UNIVERSITY OF KENTUCKY Purchasing Division

CCK-2602-22

ADDENDUM # 1

ADDENDUM #1 – BID PACKAGE #2

ENLARGED
15 THIRD FLOOR PLAN - AREA 'A4'
A4.3.A.4 1/4" = 1'-0" TRUE NORTH PLAN NORTH

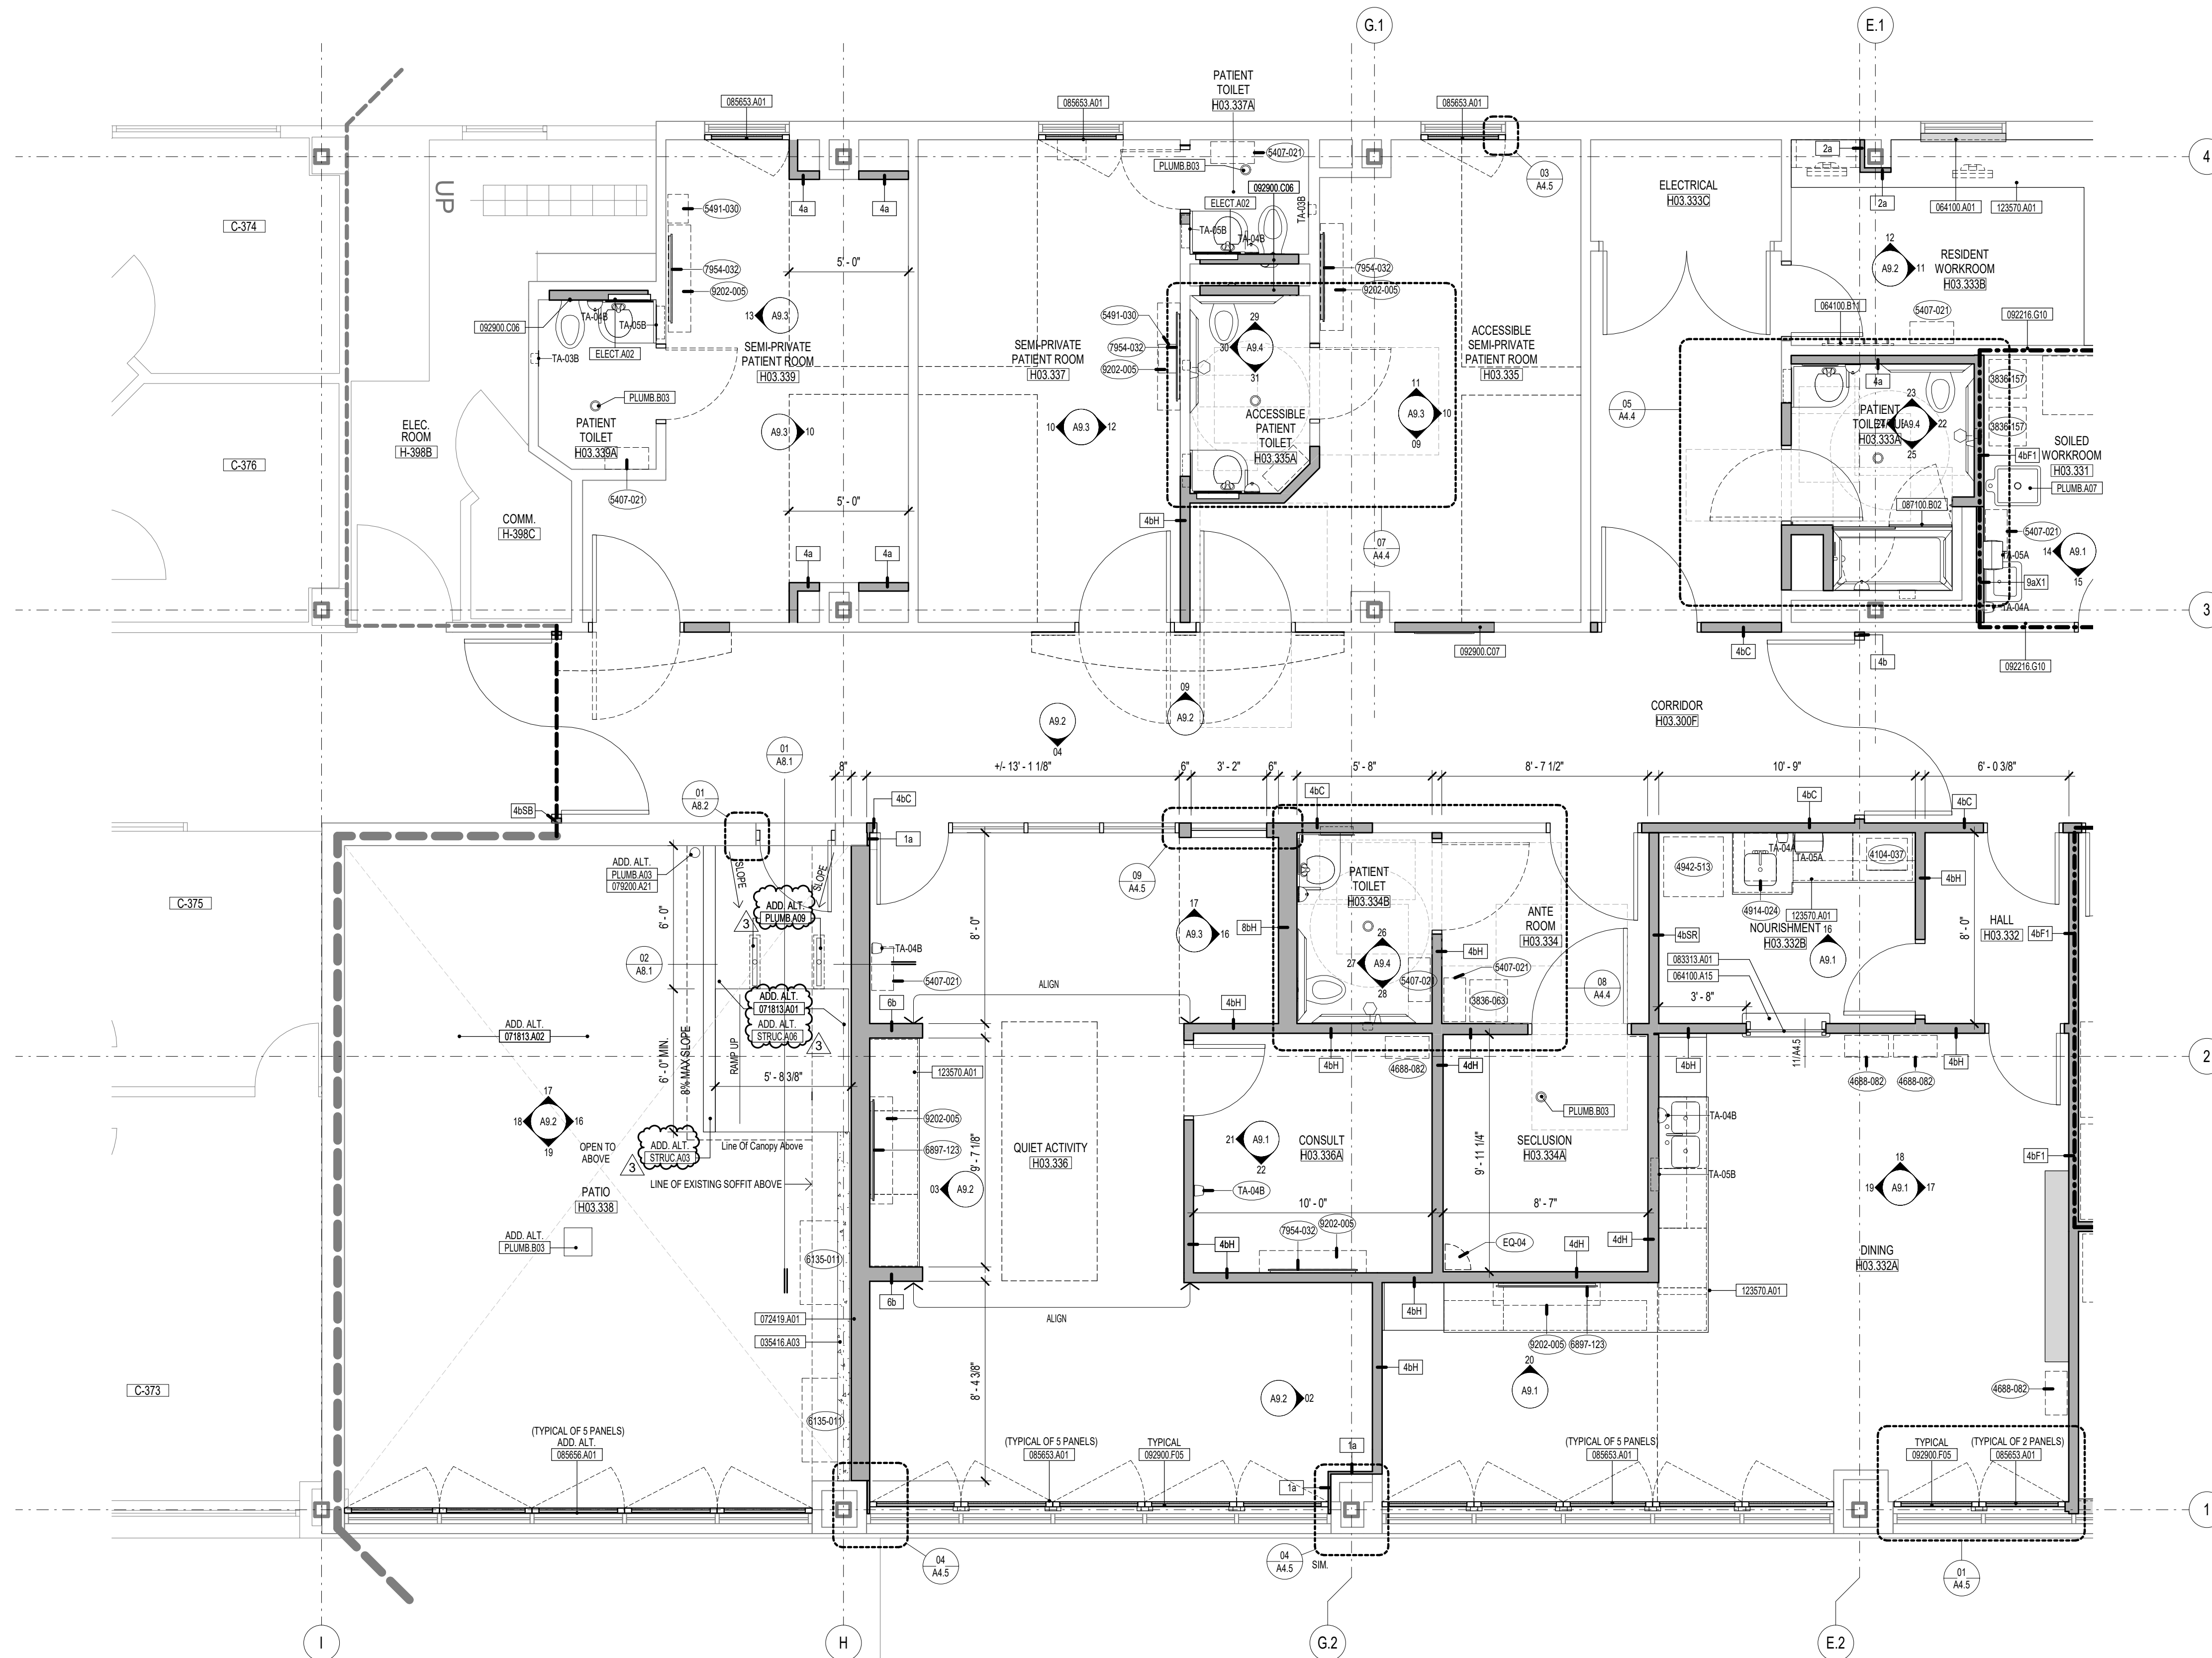
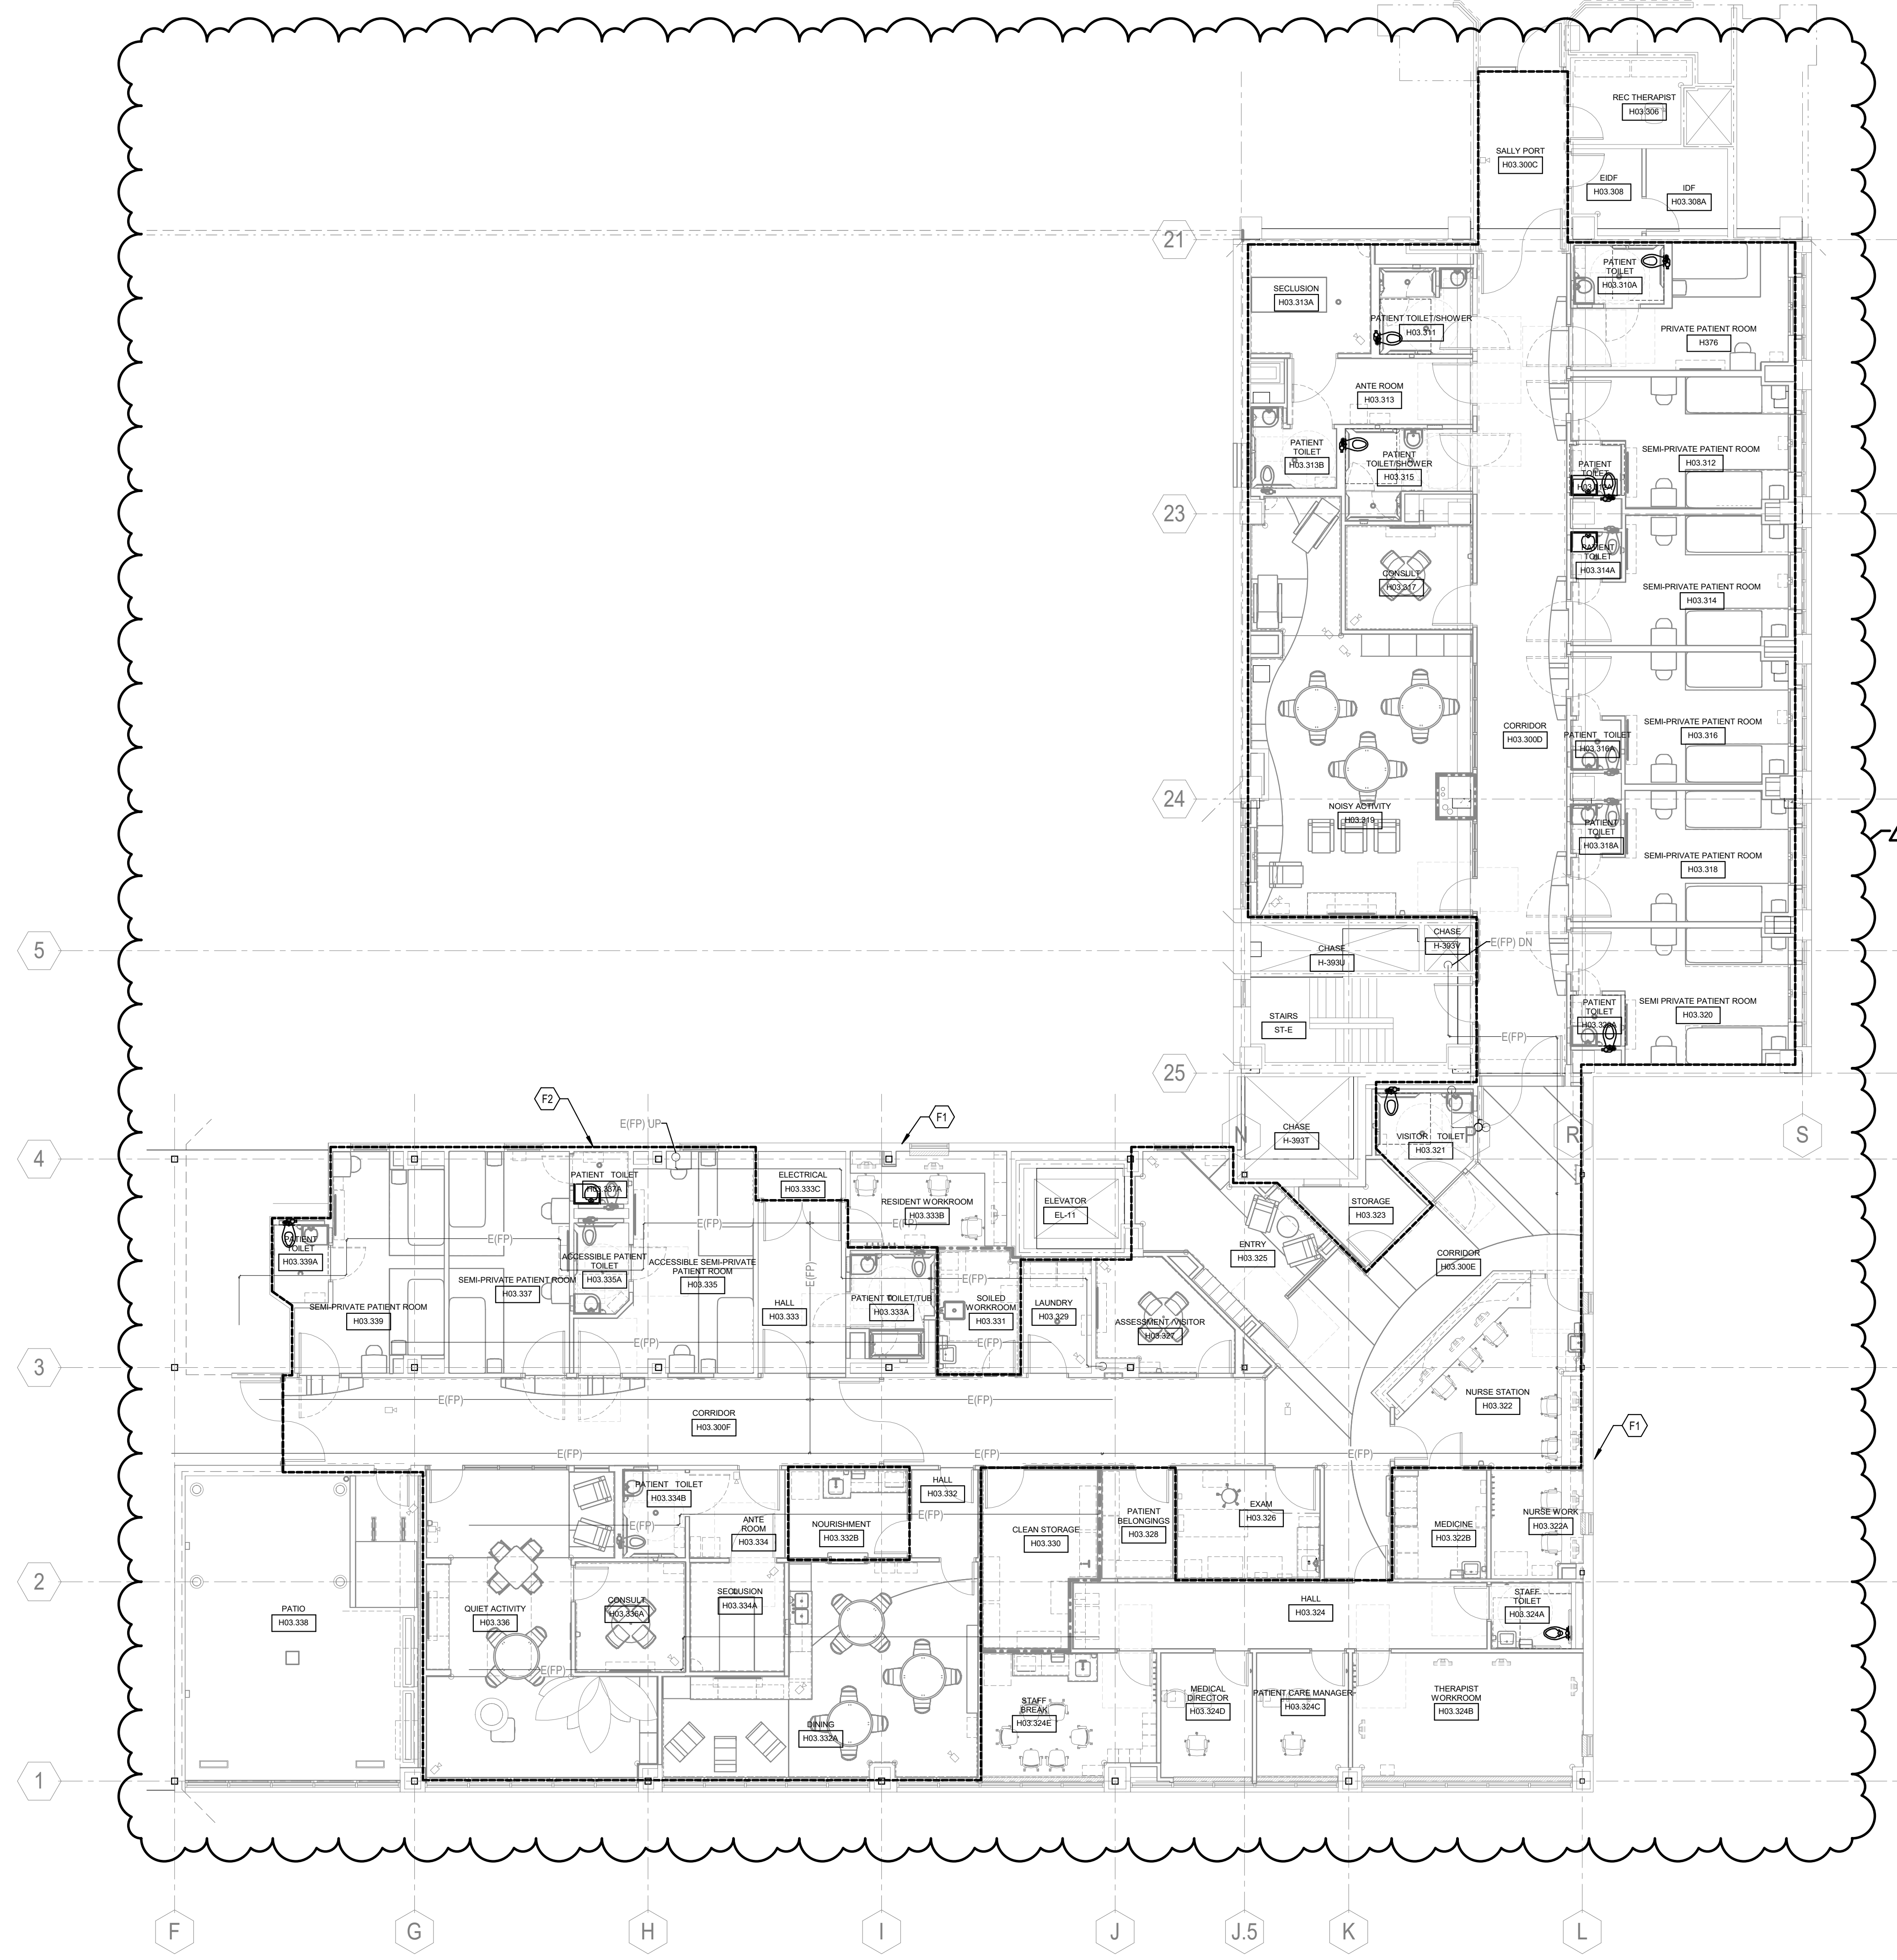
- 3.11 Reference:** Sheet A4.3.A.1, A4.3.A.2, A4.3.A.3, and A4.3.A.4 Enlarged Floor Plans
- A. **Clarification:** Added new walls added at/near Ante Room H03.313, Assessment H03.327, and Hall H03.324 where additional demolition work was needed.

P2.1

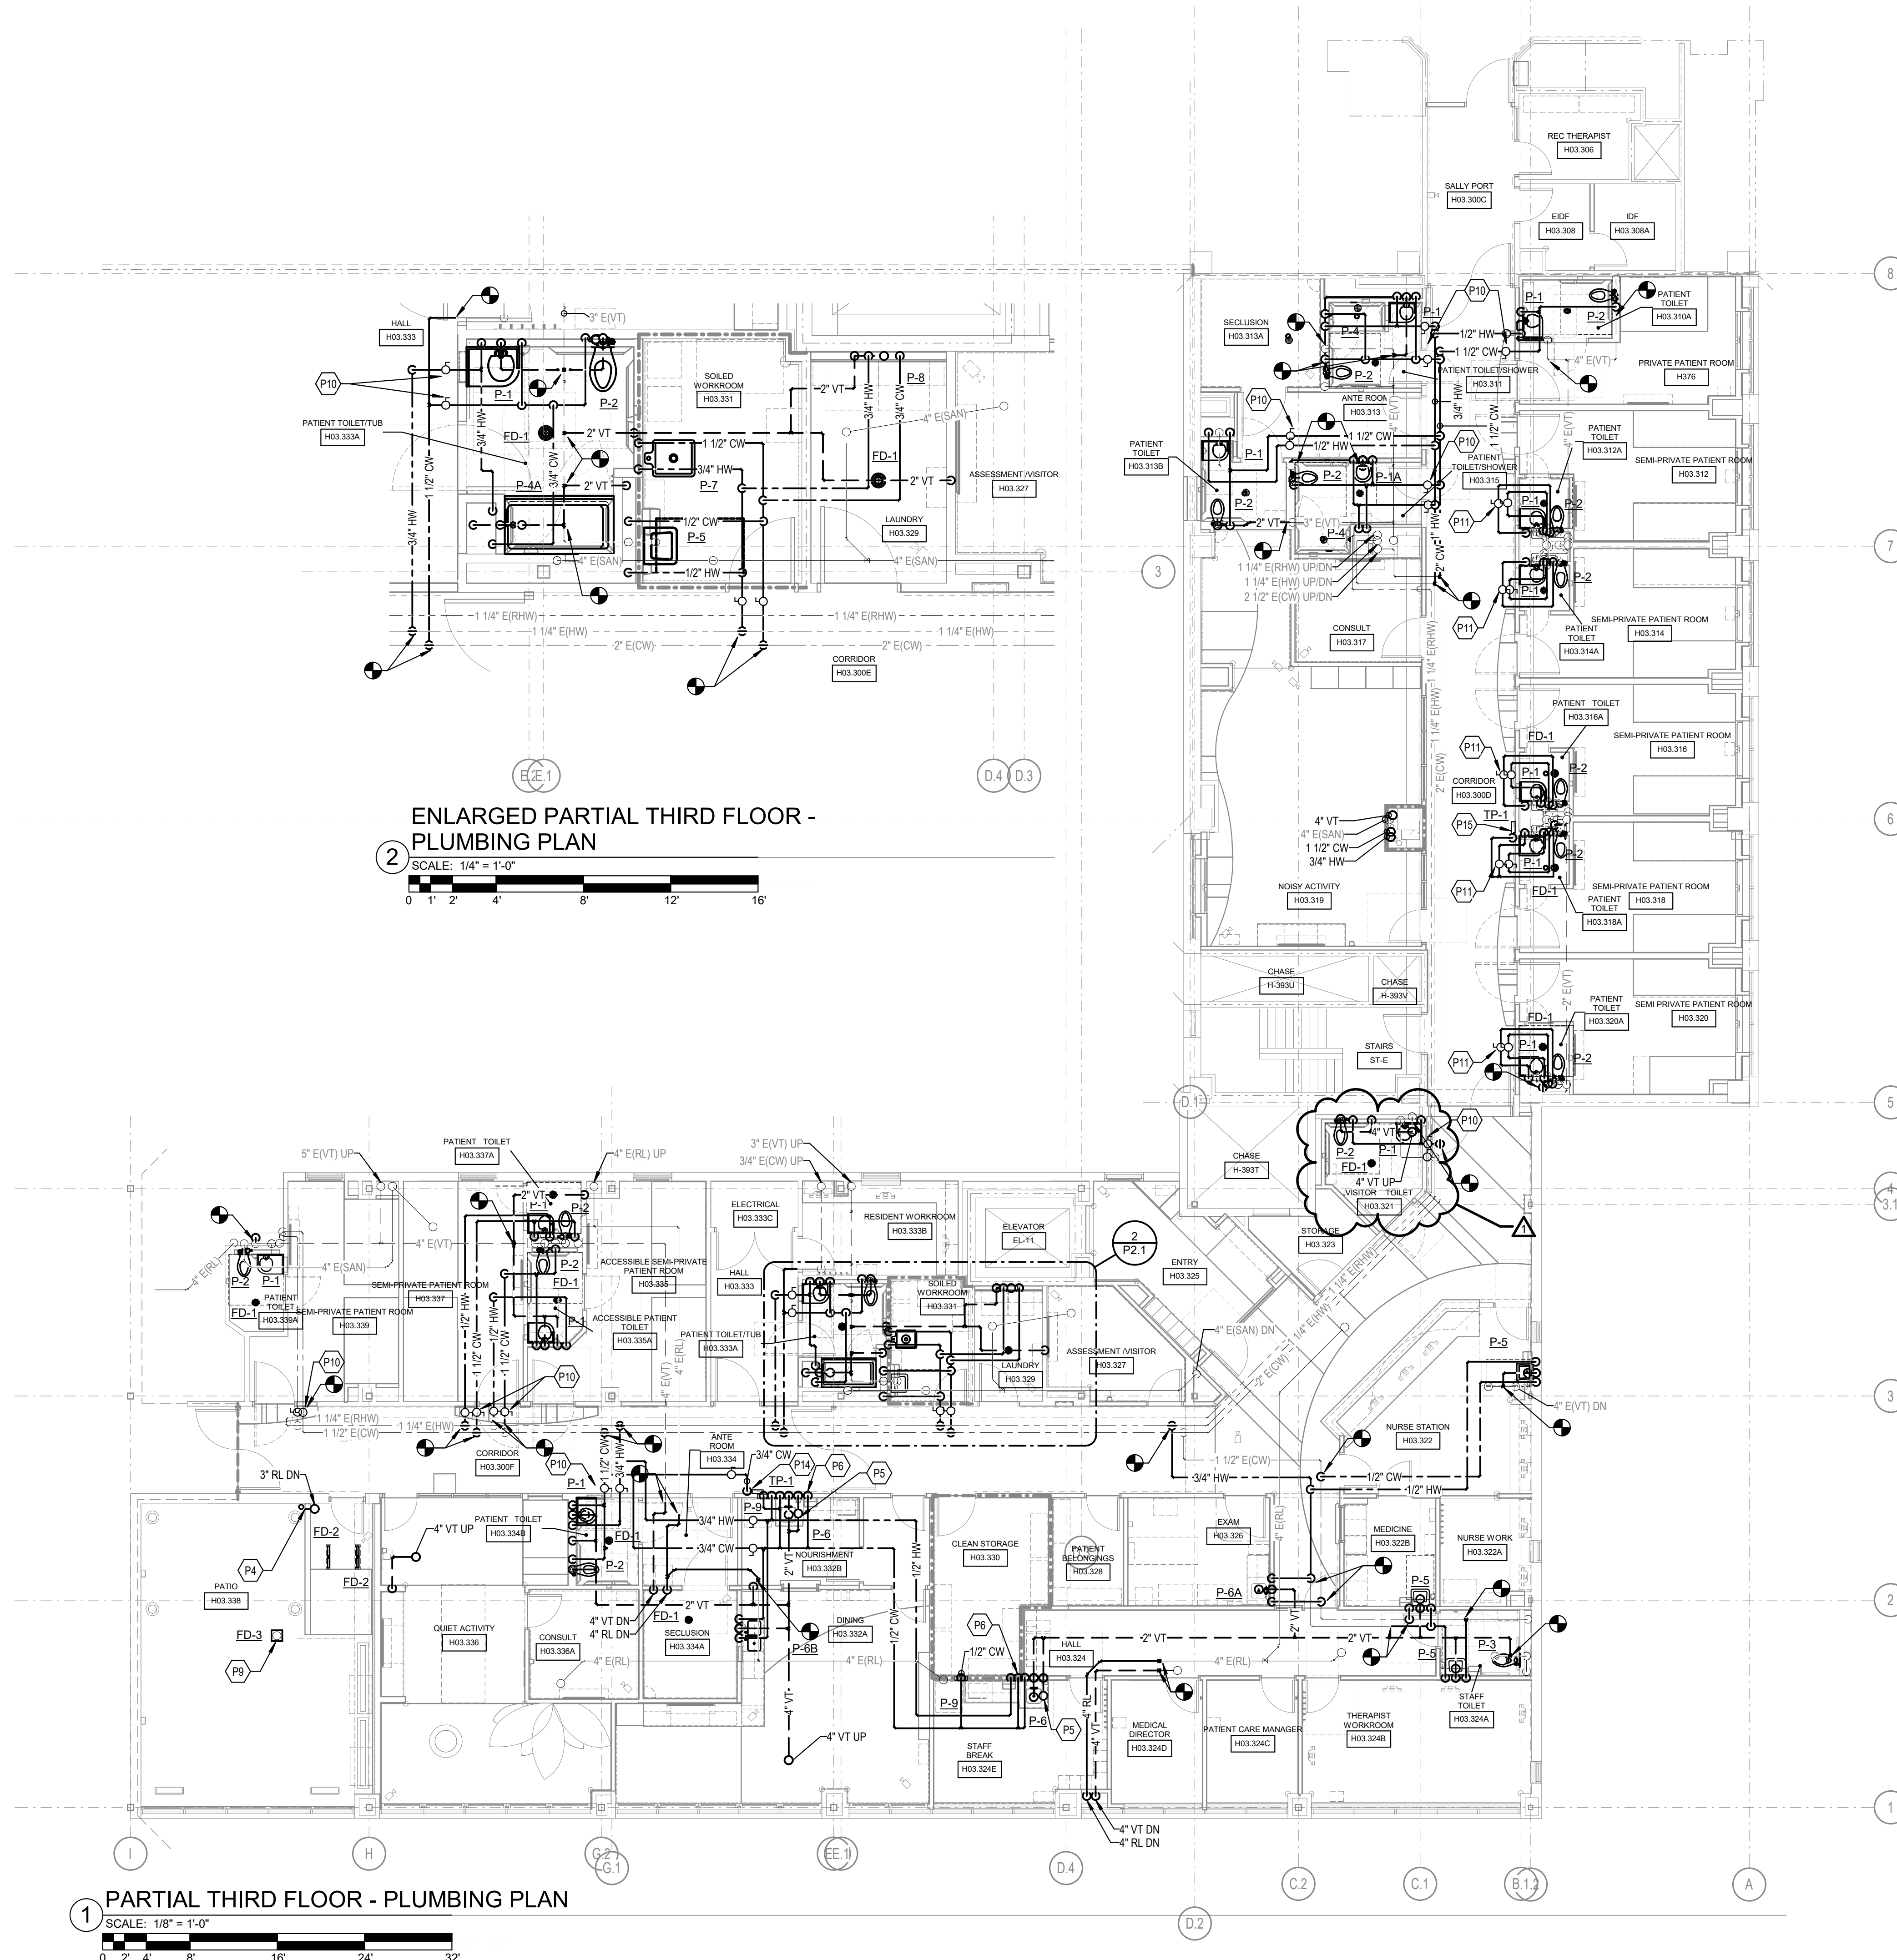
3.25 Reference: Sheet P2.1
